Proposed Temporary Warehouse for Storage of Hardware Accessories for a Period of 3 Years at Lot 1965 in D.D. 129, Lau Fau Shan, Yuen Long, New Territories

有關規劃申請 A/YL-LFS/482

TEMPORARY DRAINAGE PROPOSAL (Final)

Planning Application No. A/YL-LFS/482

Appendix C - Proposed Drainage Plan

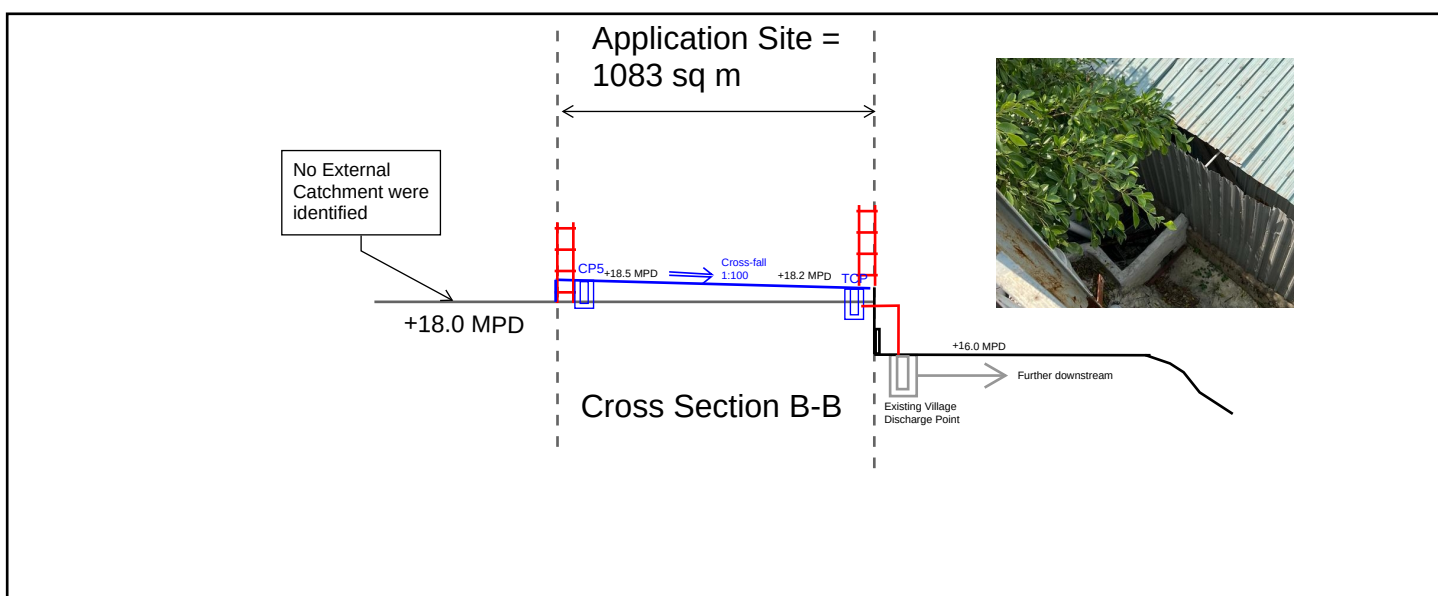
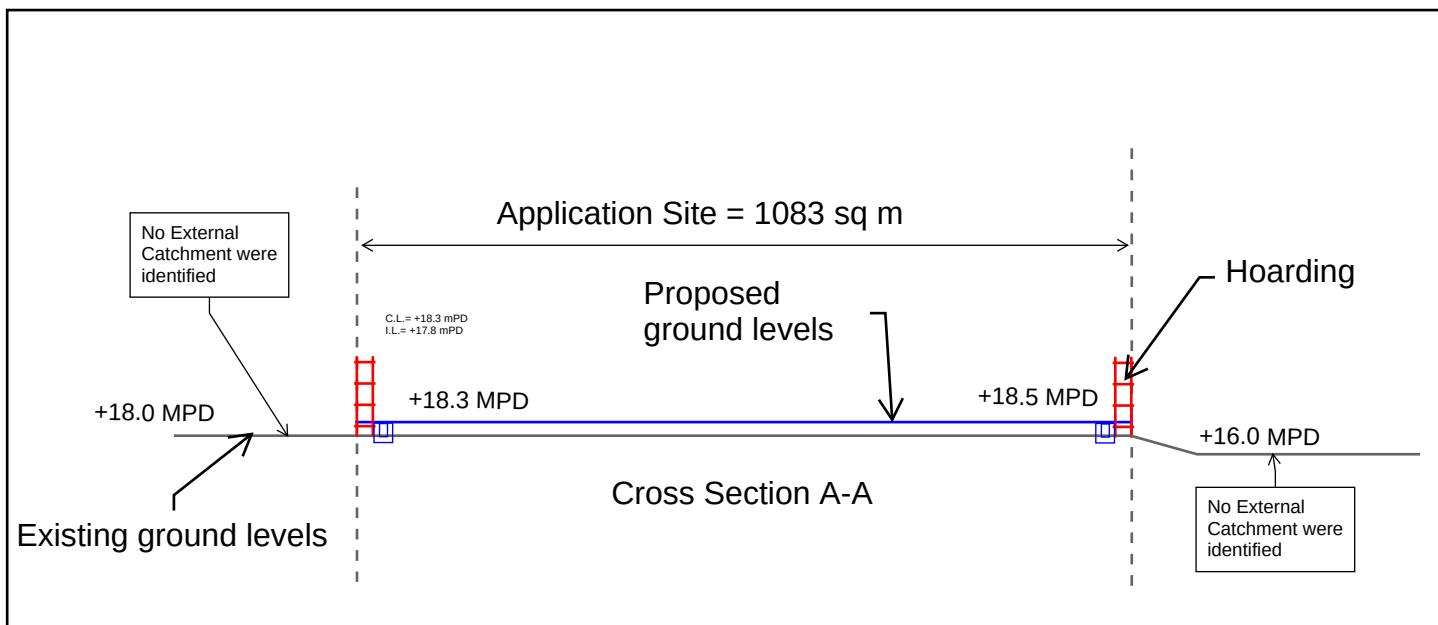
10.	Sand trap or provision alike should be clearly indicated on the proposed drainage plan and provided before the collected runoff is discharged to the public drainage facilities.	Noted and agreed. Please note that catchpit with Sand Trap (Refer Drawing No.C2406/1) are indicated in the Appendix C.

12.	The cover levels and invert levels of the proposed u-channel, catchpits/sand traps should be shown on the drainage plan.	Cover levels and invert levels are provided in the proposed drainage works as shown in Appendix C.

13.	Consideration should be given to provide grating tor the surface channels.	Noted with thanks. Cast iron grating would be provided underlaid the main entrance as specified in Appendix C refer to CEDD's standard drawings C2412E.

Proposed Catchpit with
Sand Trap (Refer Drawing
No.C2406/1)

Proposed 300mm Surface
U-channel with grating (Refer
CEDD Standard drawing No.
C2412E)

Proposed Terminate
Catchpit with Sand Trap
(Refer Drawing No.C2406/1)

Site Photo 1 for Electric Room

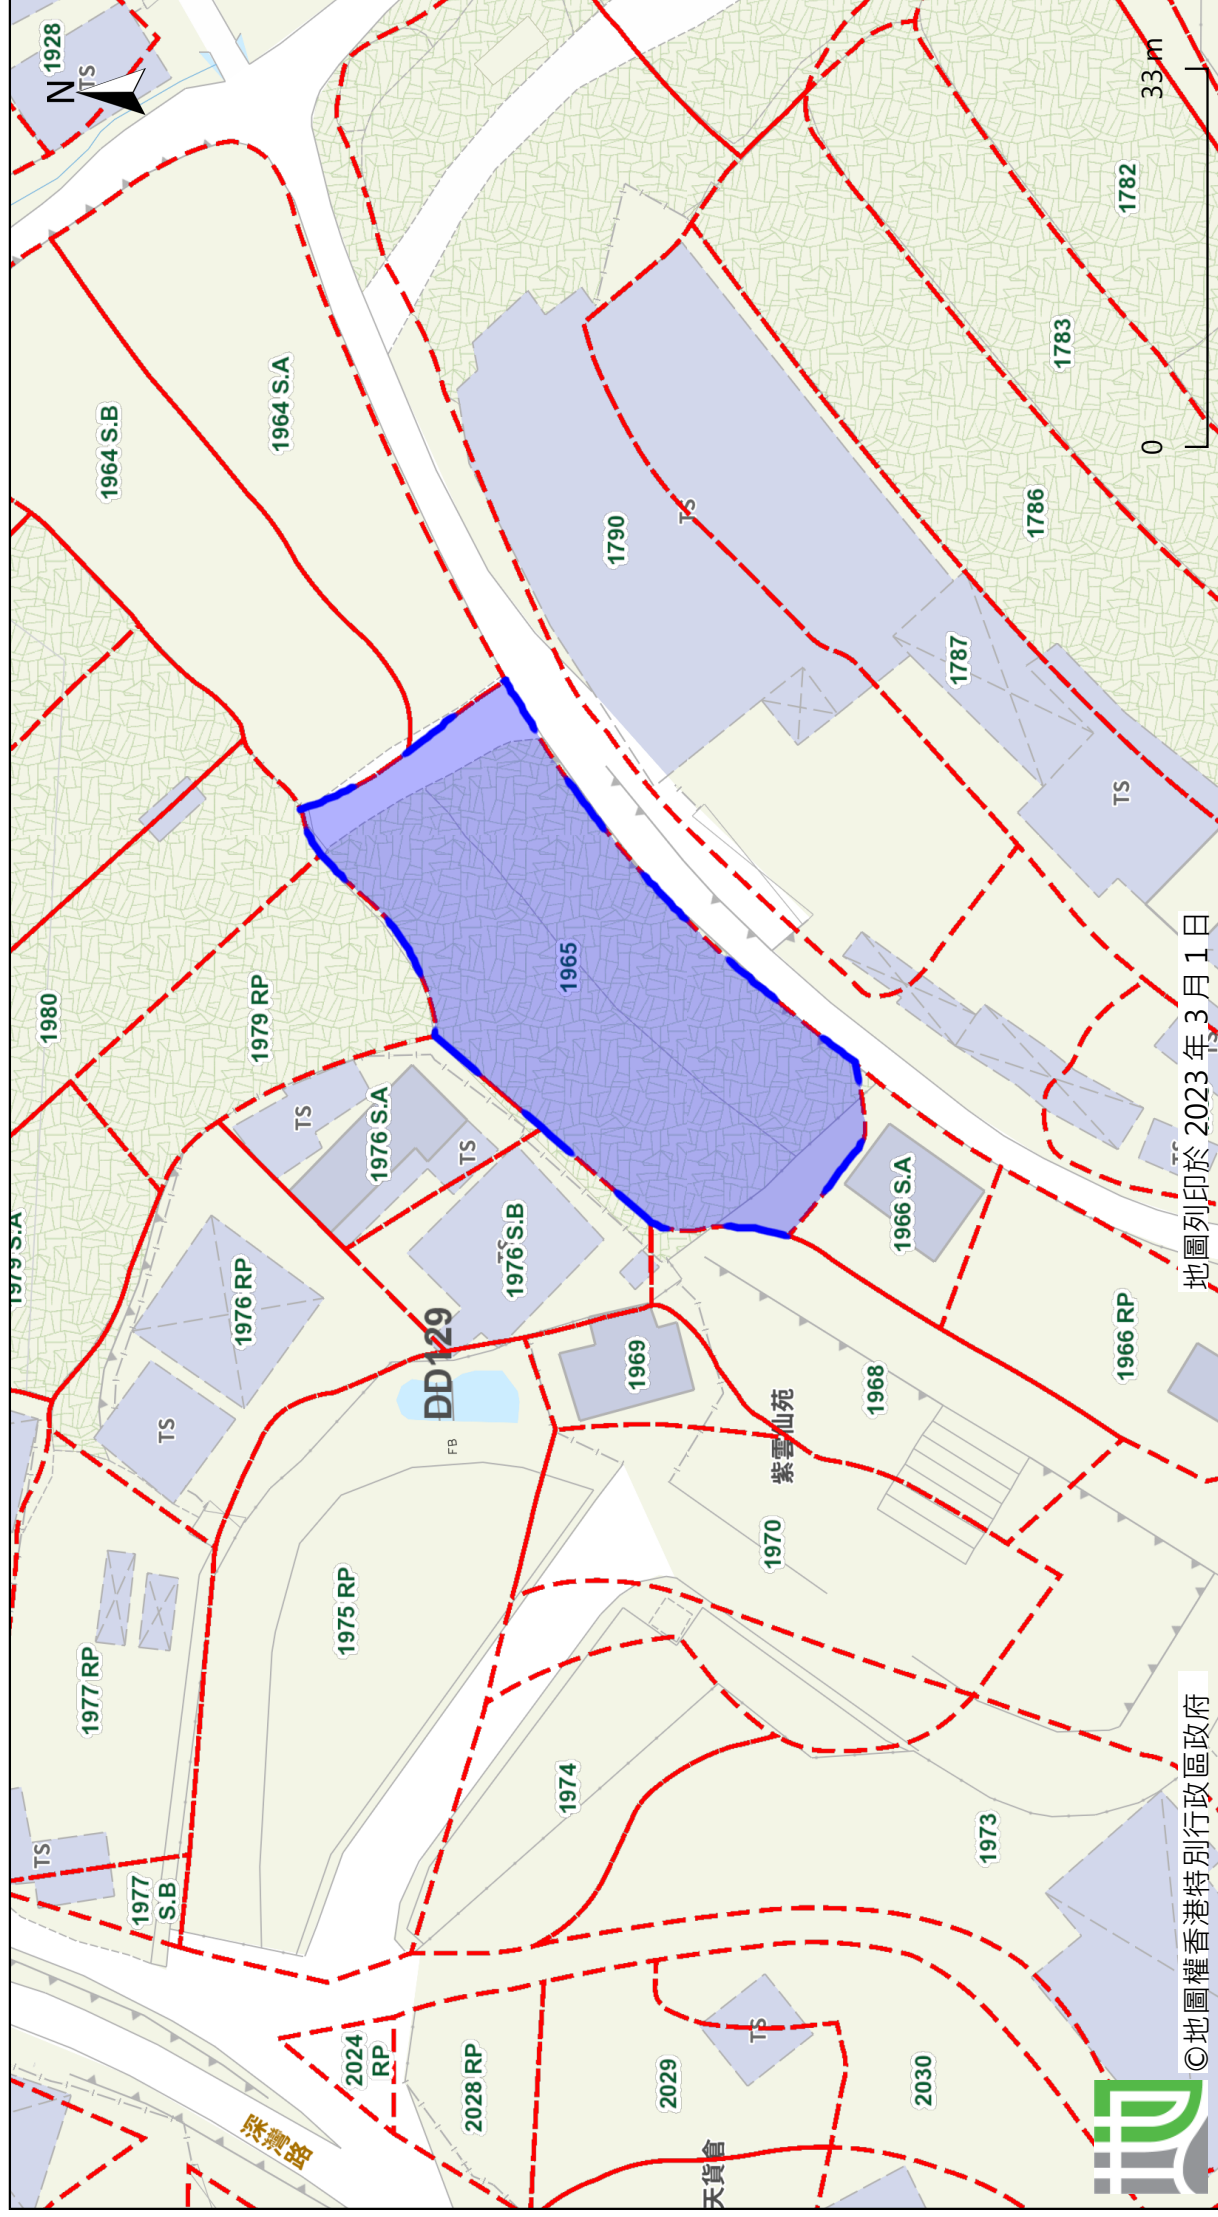
Please be advised that the electric room would not clash with the proposed u-channel, you may refer to the site photos for the clarification

Photo 1

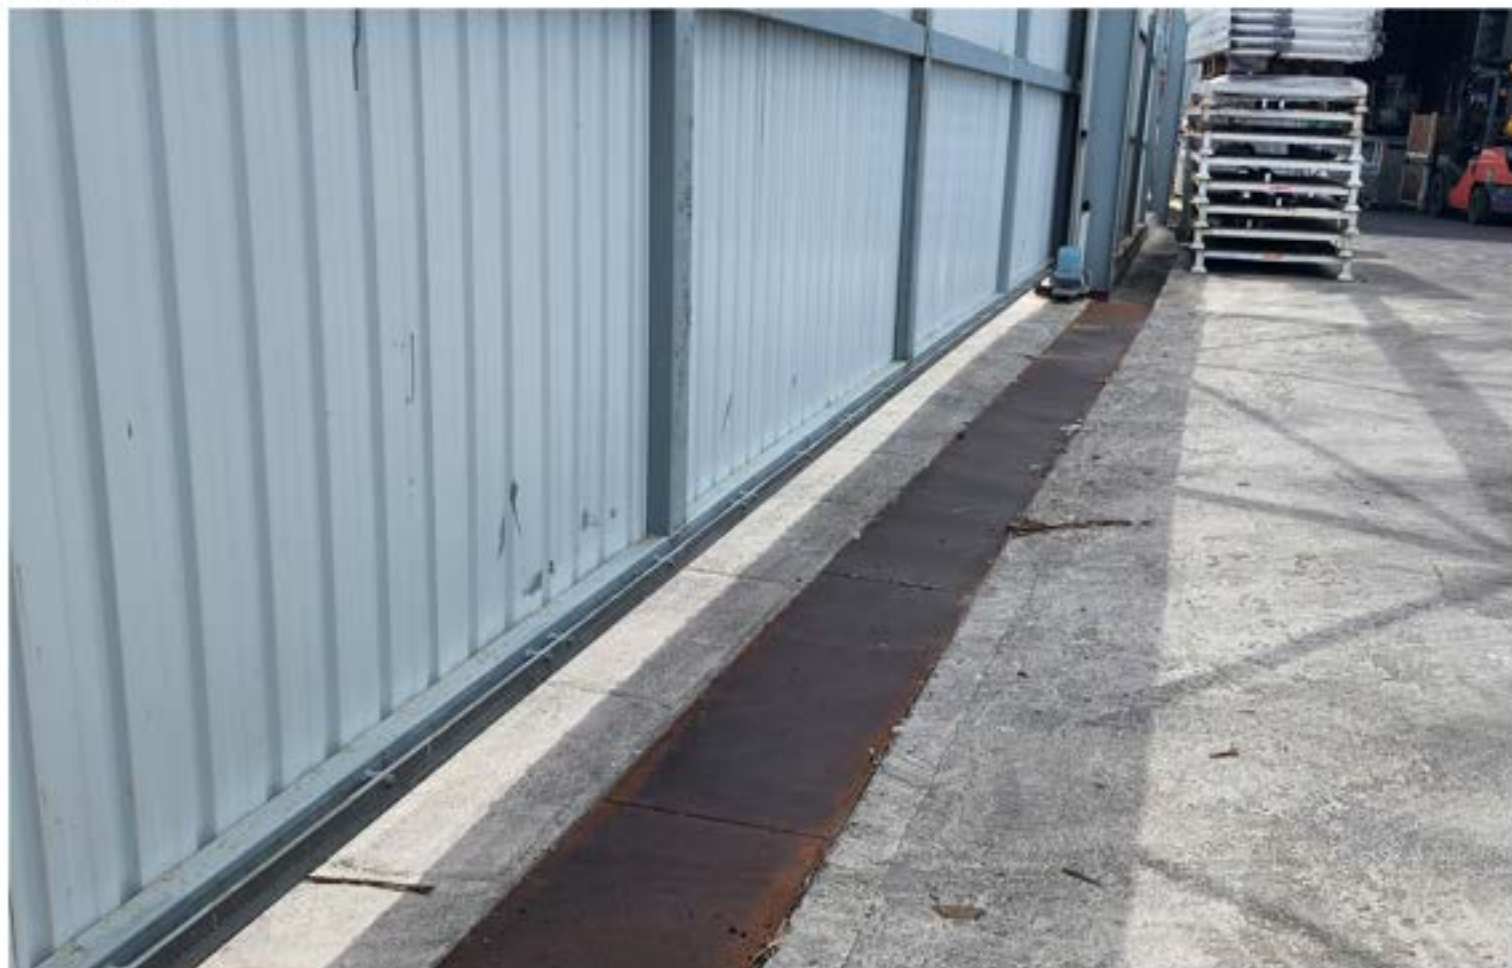
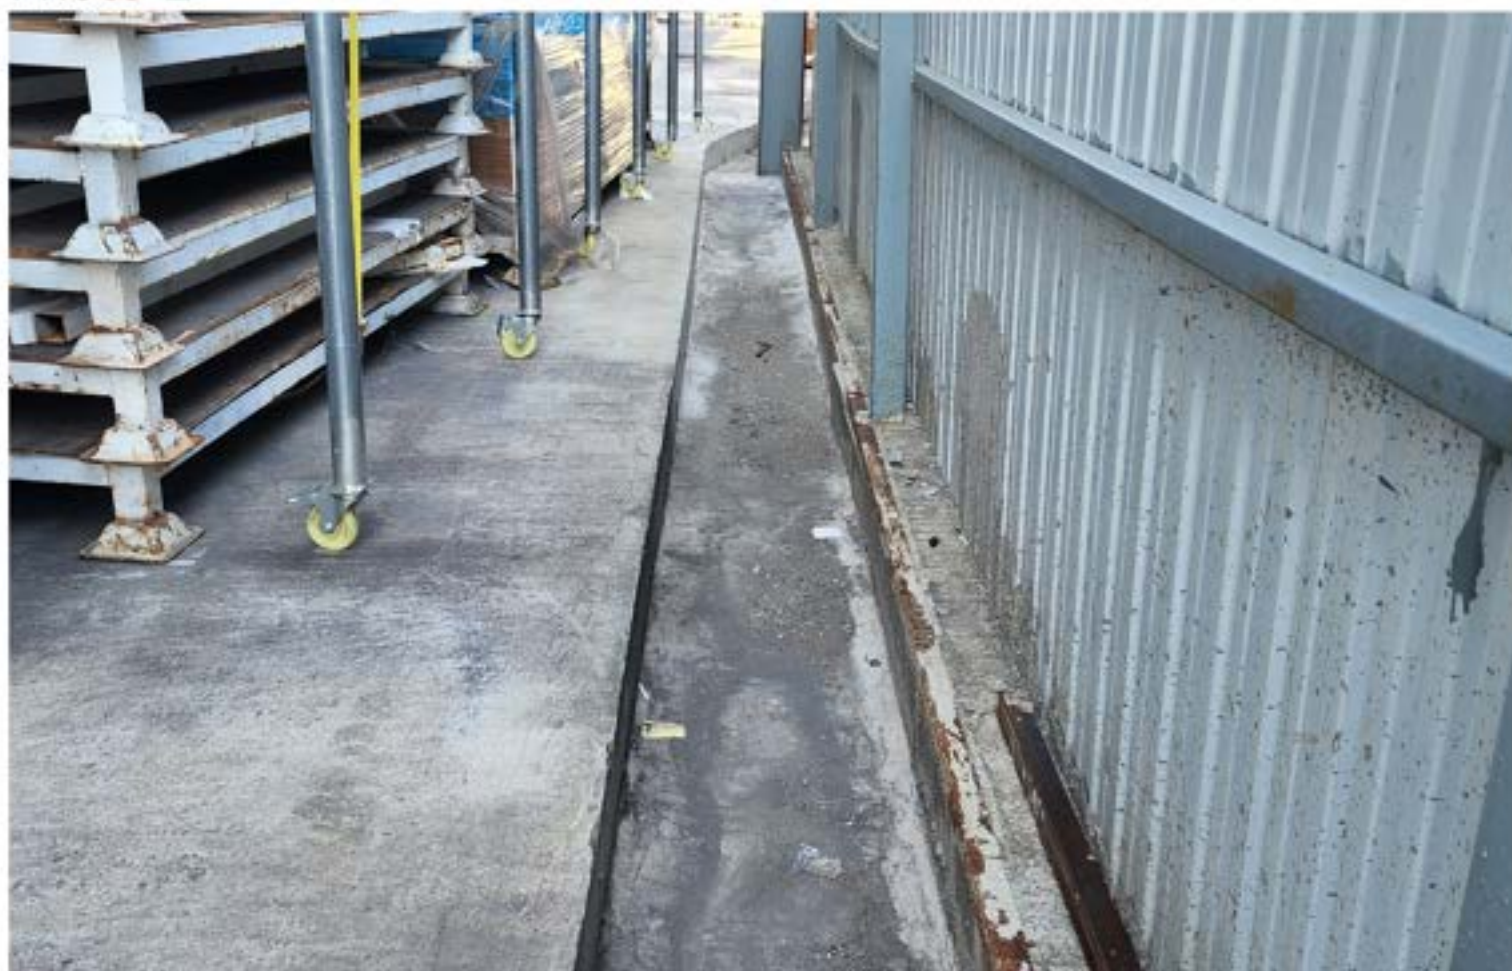
No.	Comments	Response
19	Environmental Protection Department should be consulted as regards the sewage disposal aspects (if any).	Noted.
	Besides, please note that the photos submitted by the applicant demonstrating the implementation of drainage proposal is not acceptable due to the following reasons.	
1	Satisfaction of implementation of drainage proposal is subject to the acceptance of drainage proposal.	Noted and provided, the proposed drainage arrangement is within submitted.
2	Applicant should demonstrate that the size, including width and depth, of U-channels and catchpits /sand traps complied with the drainage proposal.	Cover levels and invert levels are provided in the proposed drainage works as shown in Appendix C.
3	Site photos of existing drainage facilities including the discharge point (e.g. existing local village drain mentioned in the proposal and its downstream drainage facilities) should be provided in order to demonstrate the presence and reflect condition of the existing drainage system.	Noted and provided. The site photo showing the existing discharge point is shown in Appendix C.

4	Insufficient openings on hoarding for drainage purpose.	Please be clarified that the ground level of application site is generally higher than the adjacent ground surface, no external catchment shall be considered in the calculation. Thus, there should be no overland flow passing through the site.
5	Drainage channel is blocked by steel materials and debris.	Noted, proper drainage system would be maintained.
